2 December 2021

**Re: Design Submission for Old Bray Road, Cornelscourt, Dublin 18, Co. Dublin (the “Development”)  
(the “Design Submission”) / Connection Reference No: CDS20003703**

### Appendix A

DRG TITLE: **SITE SERVICES LAYOUT - SHEET 1**

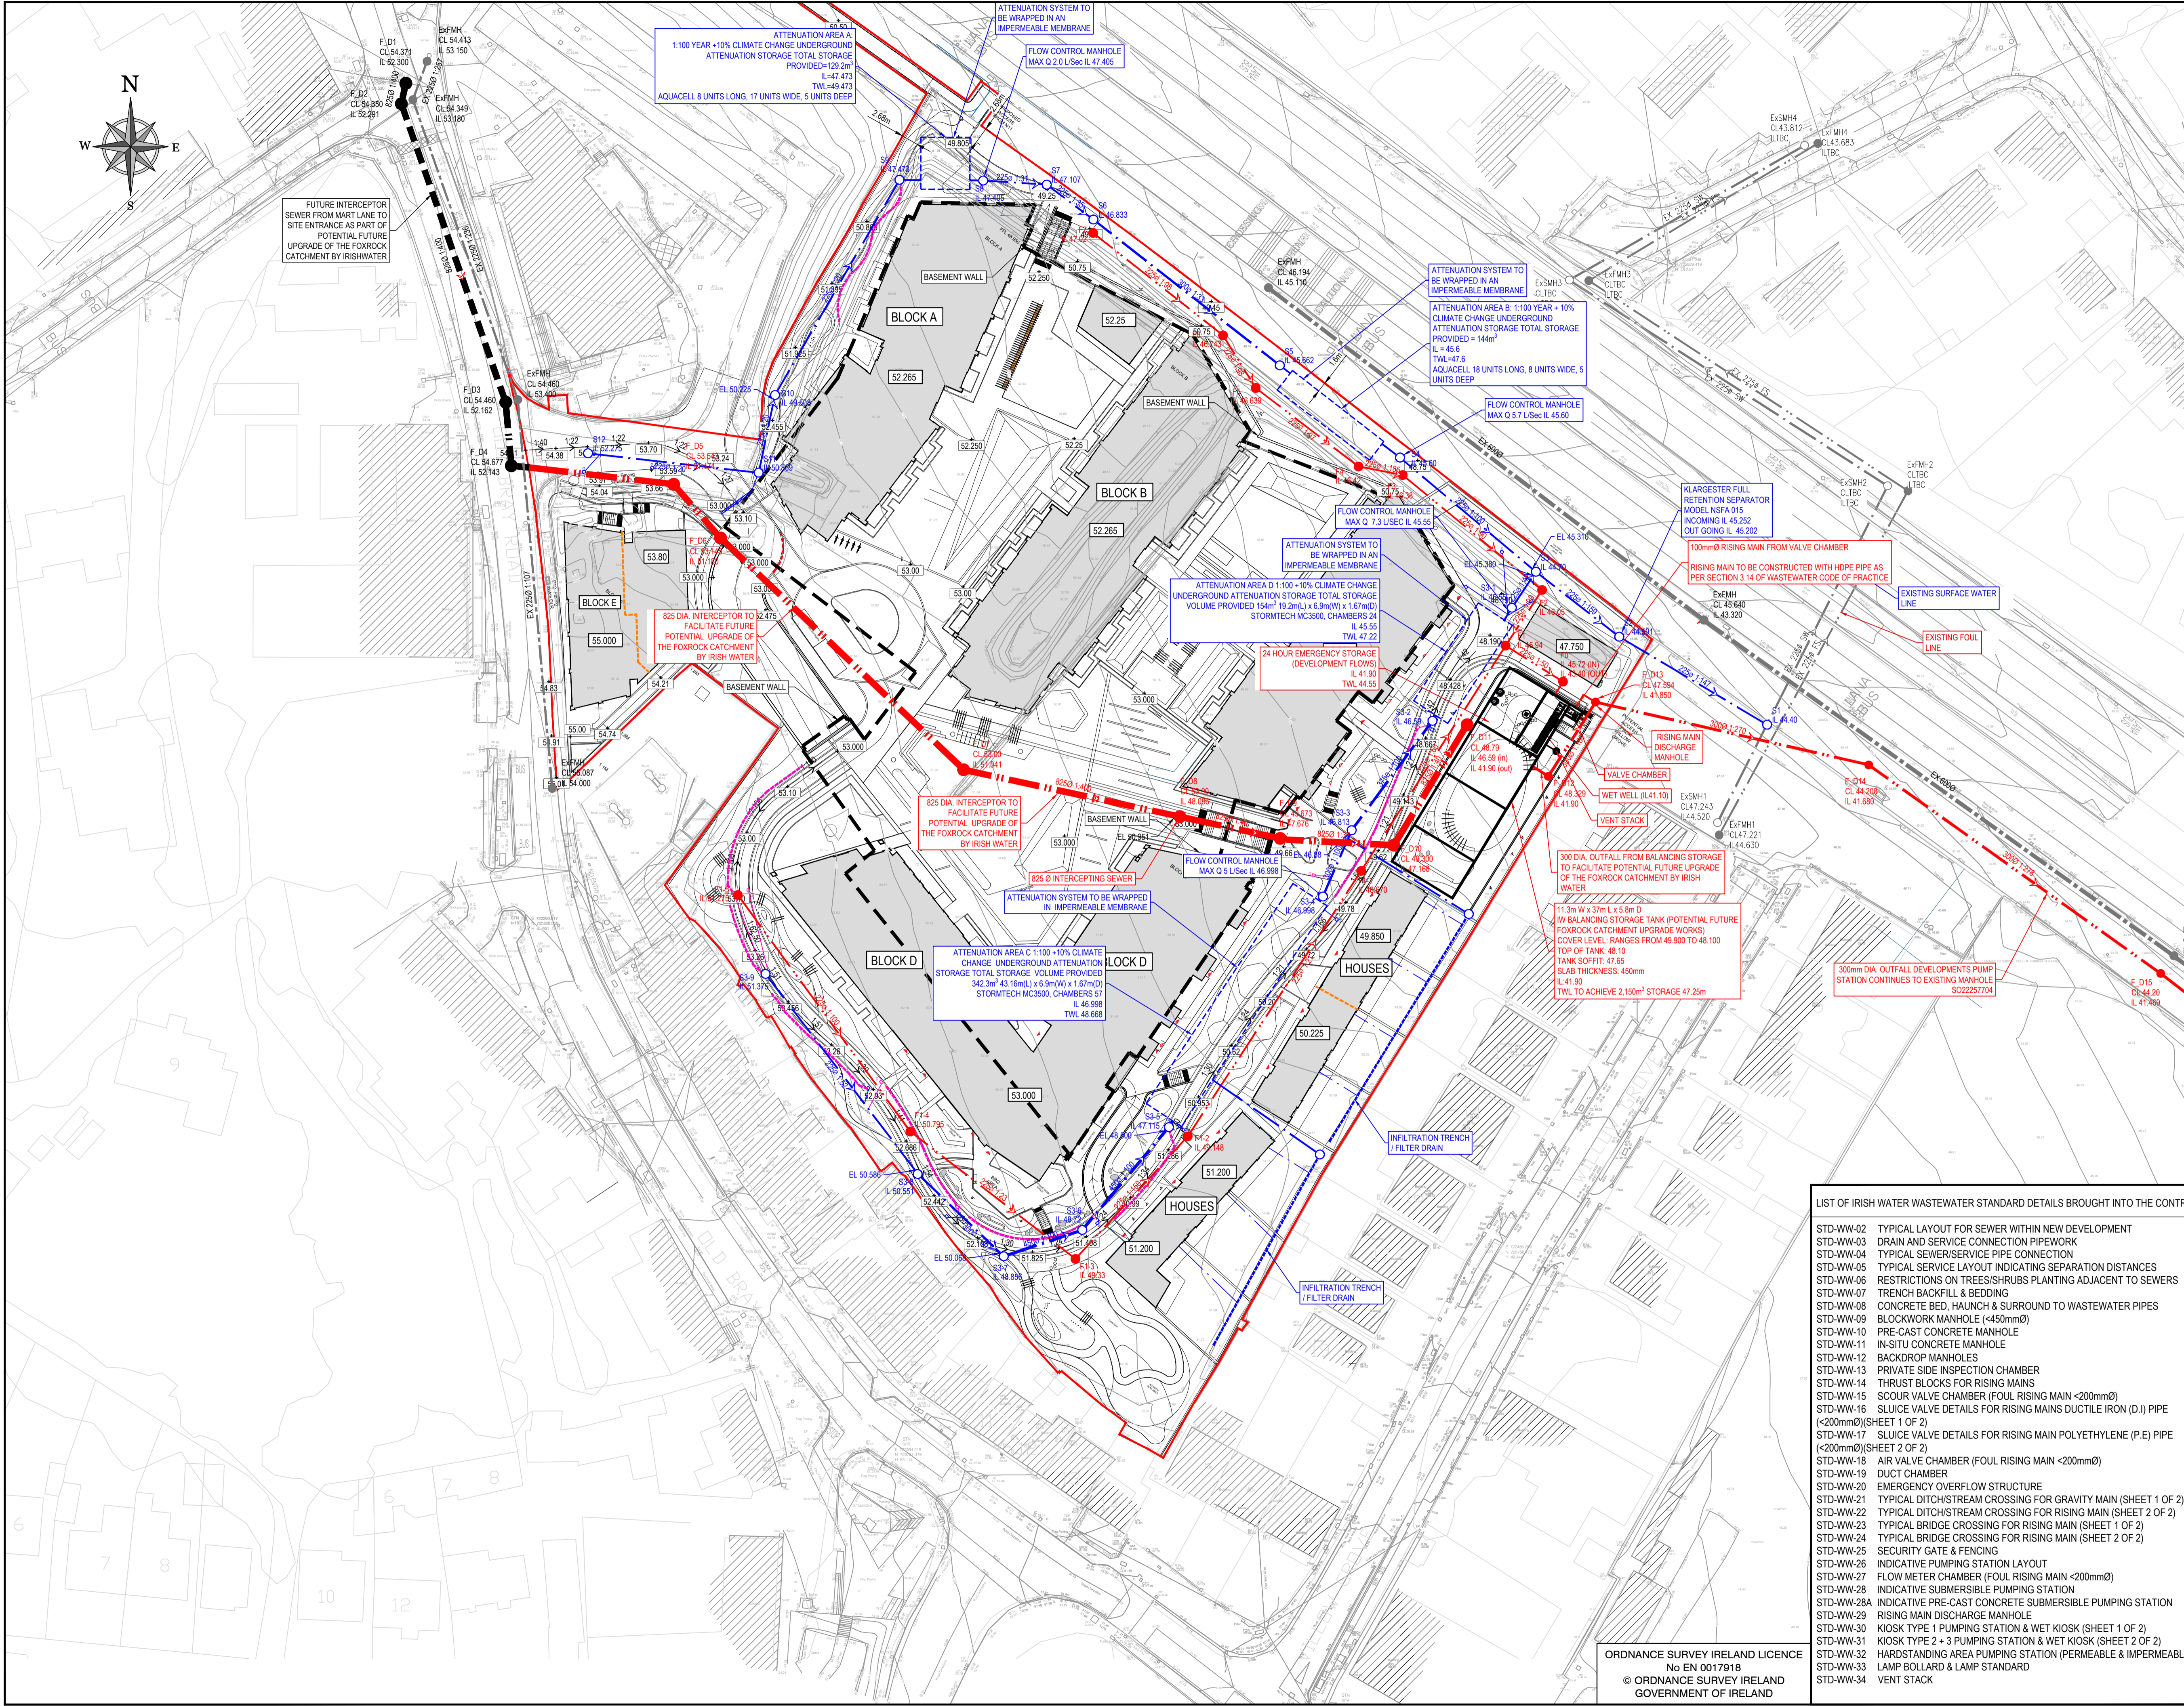
**This Statement of Design Acceptance does not extend to the proposed 825mm diameter interceptor pipe.**
